***Sampling and Analysis Plan
for the
Site Characterization of the 903 Drum Storage Area
903 Lip Area, and Americium Zone***

Responses to Additional Agency Comments

January 21, 1998

Response to Additional Comments from Colorado Department of Public Health and Environment, Hazardous Materials and Waste Management Division, on the Sampling and Analysis Plan for the 903 Drum Storage Area (IHSS 112), 903 Lip Area (IHSS 155), and Americium Zone, dated September 18, 1997 (Revision 0).

Well 8891 Time Series

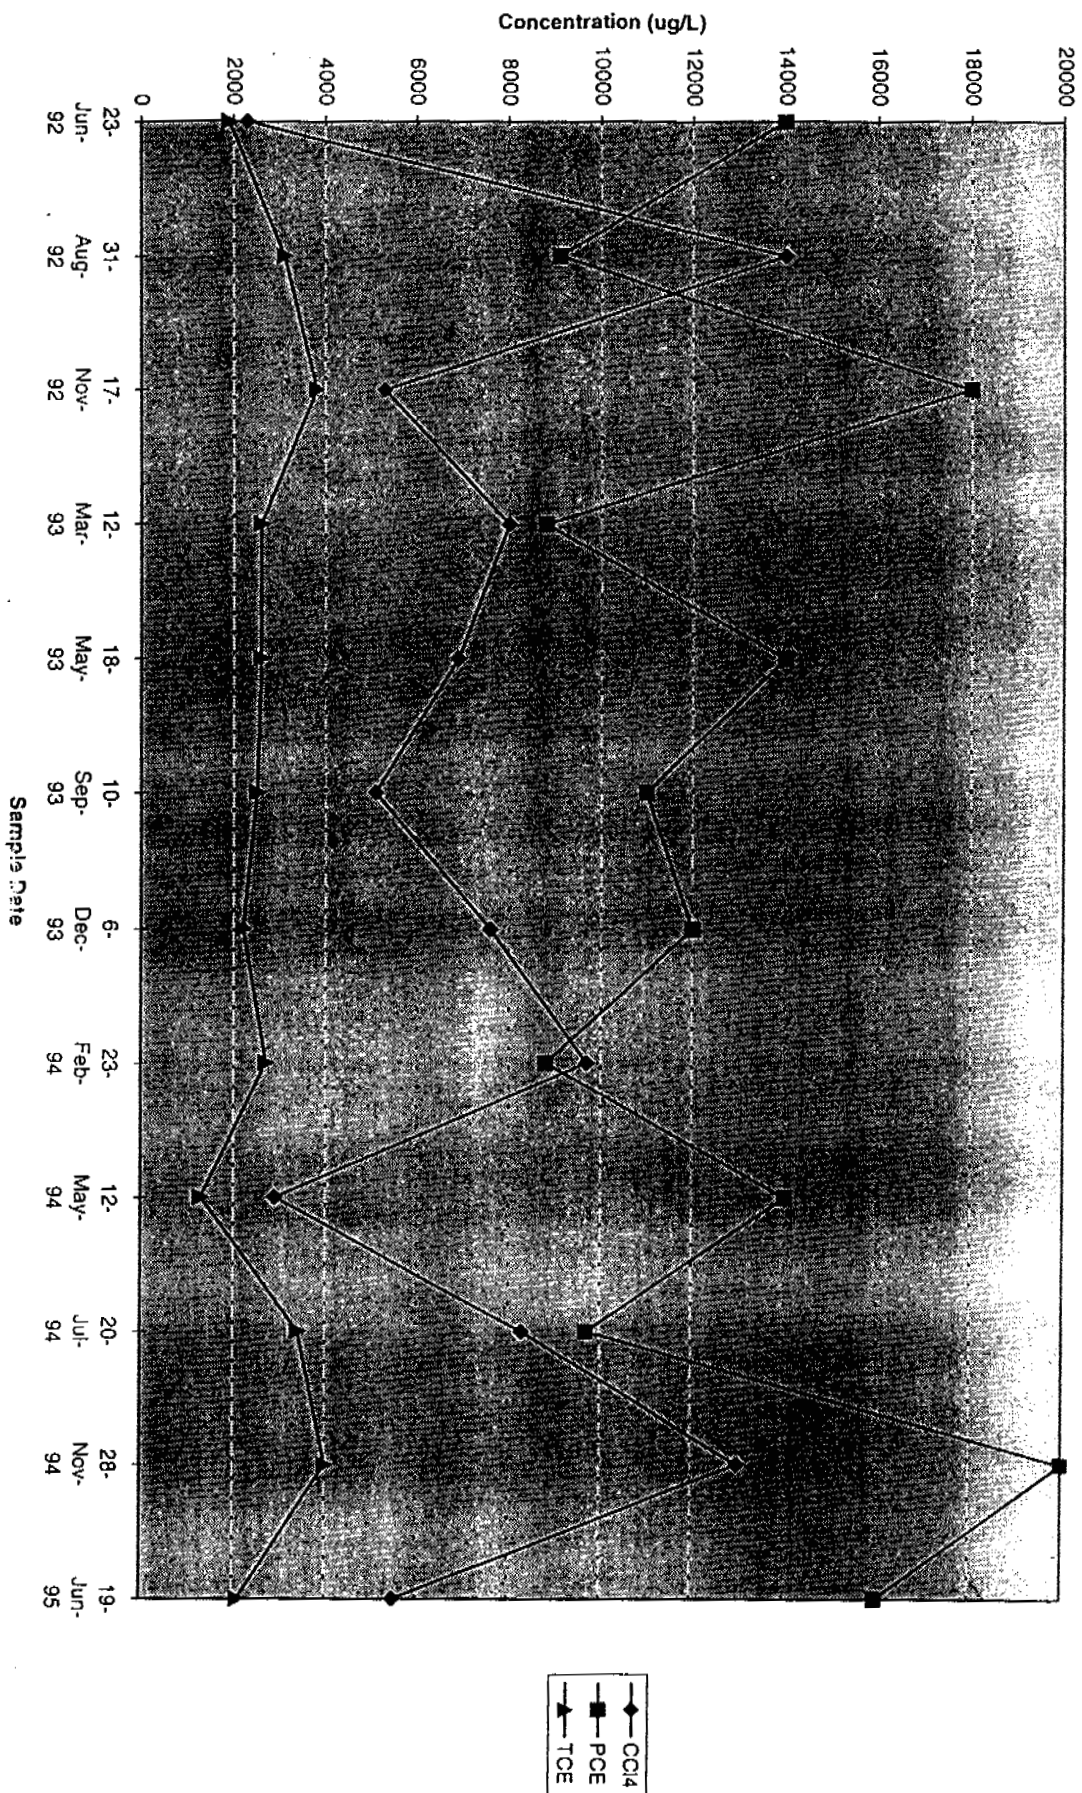
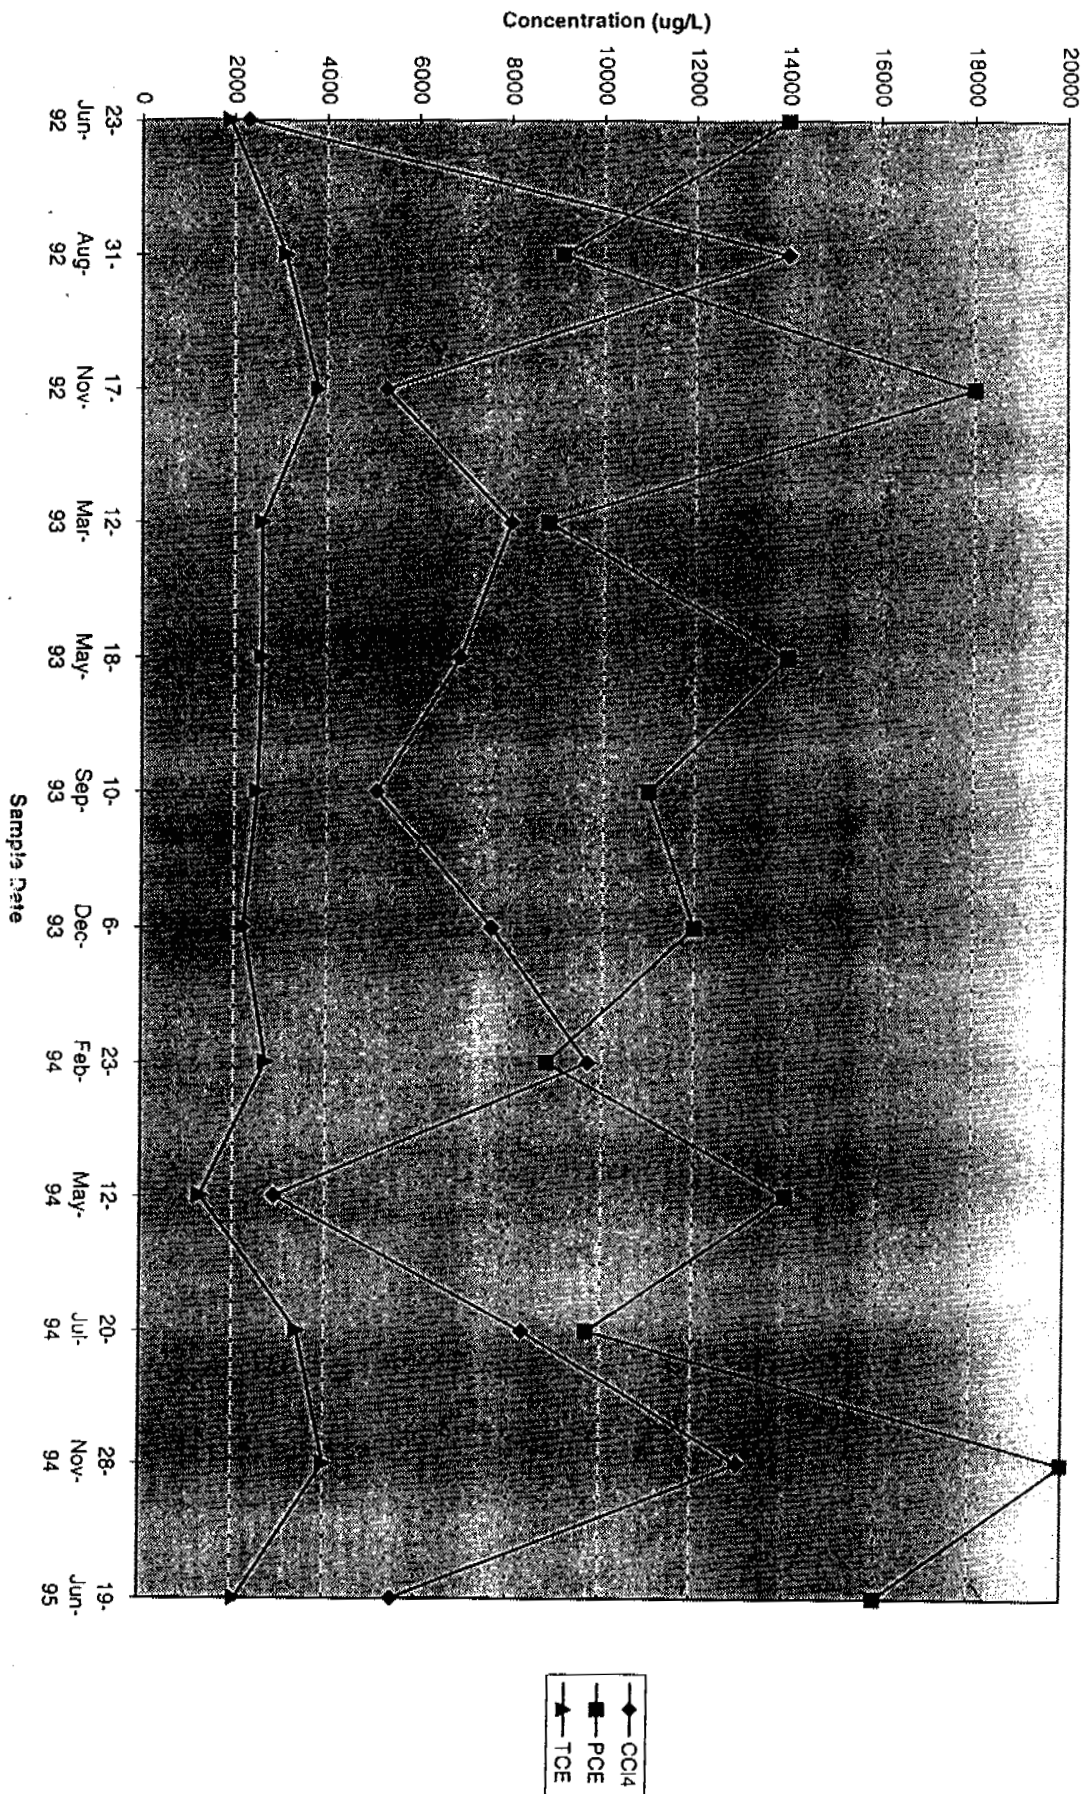
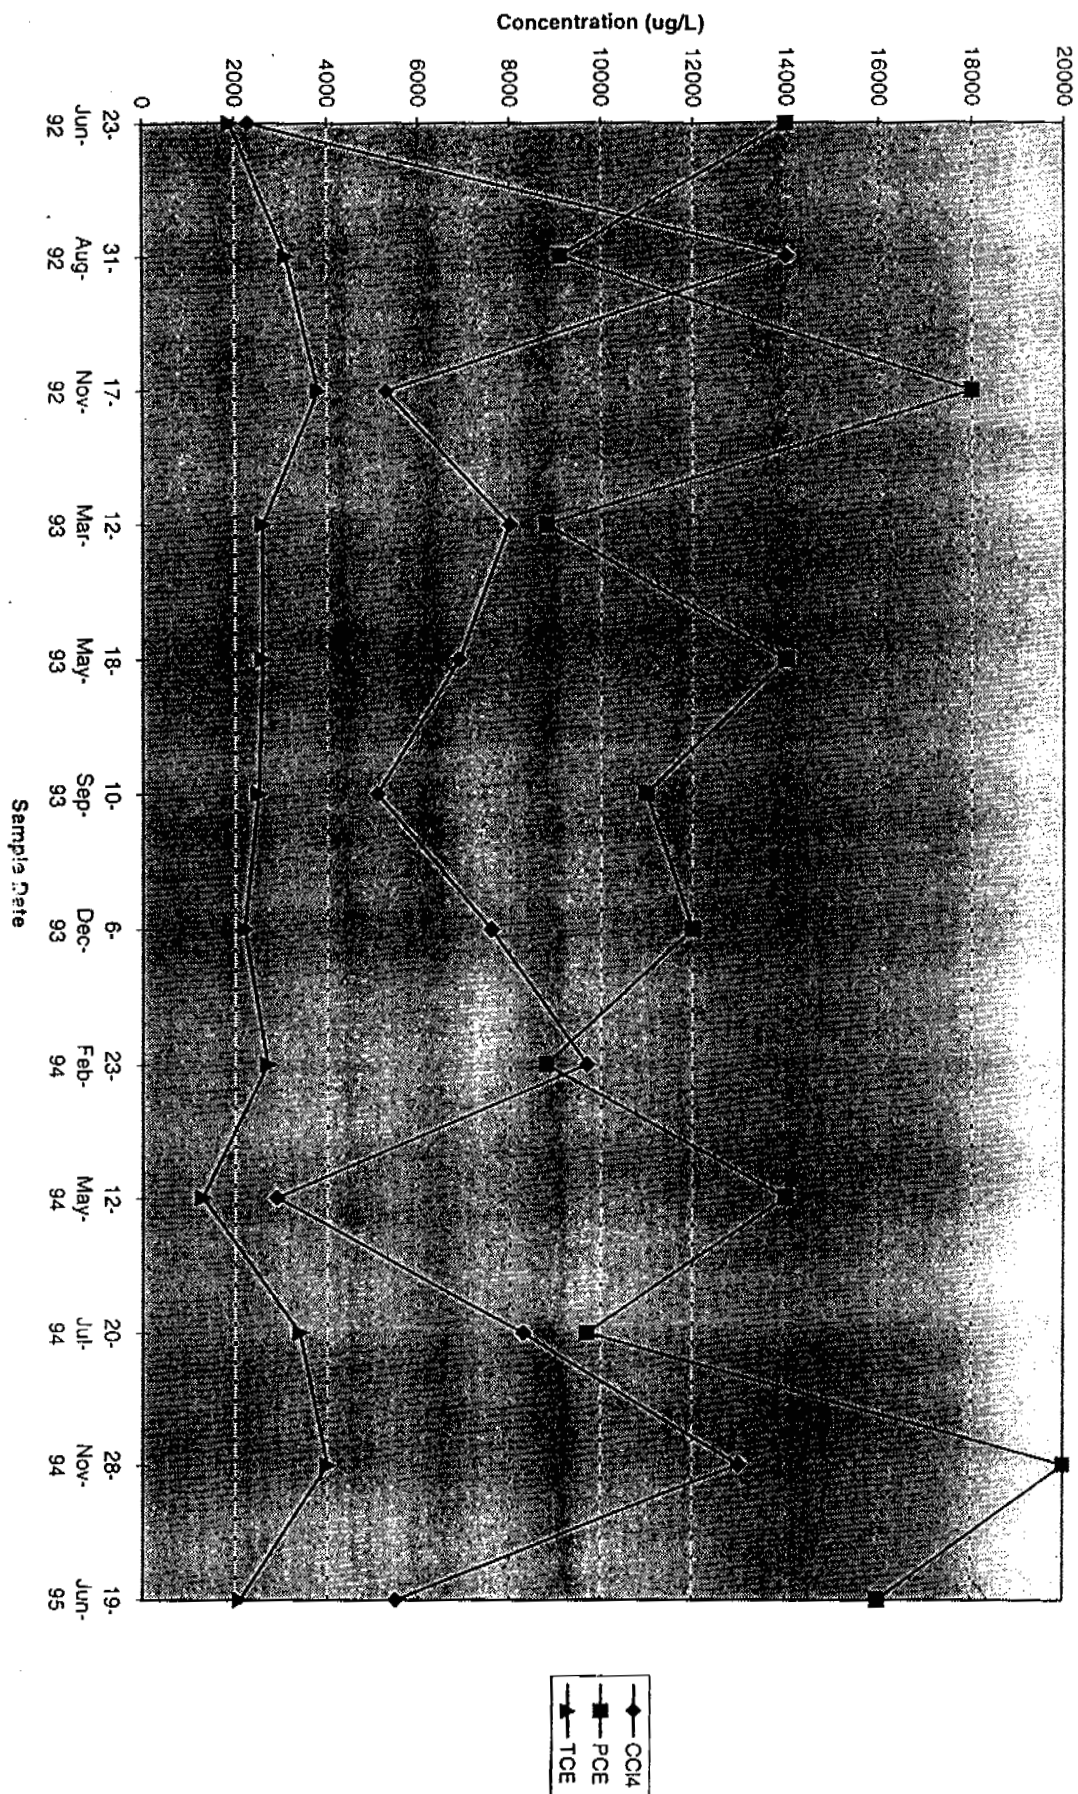
Section 1.2.3 provides background and a basis for additional groundwater investigations, but does not seem to be based on all the available data. Existing groundwater data should be presented in time series and evaluated. An evaluation should include whether VOC concentrations at a well are increasing or decreasing with time and whether concentrations increase with depth. Any pertinent data from soil or bedrock samples should also be presented.

A discussion of the time series evaluation of the VOC concentrations in well 6691 and 8891 was omitted from the text in the SAP because there is no significant change in concentrations over time. The attached time series chart for well 8891 reflect continuous concentrations of PCE, CCl₄, and trichloroethene. The attached time series chart for well 6691 reflect an overall slight increase in the concentration of CCl₄ over time. The CCl₄ concentration from well 6691 are well above one percent of the solubility of CCl₄. The data from both wells indicate a nearby upgradient source for the VOC contamination. The subsurface VOC investigation is designed to locate these sources.
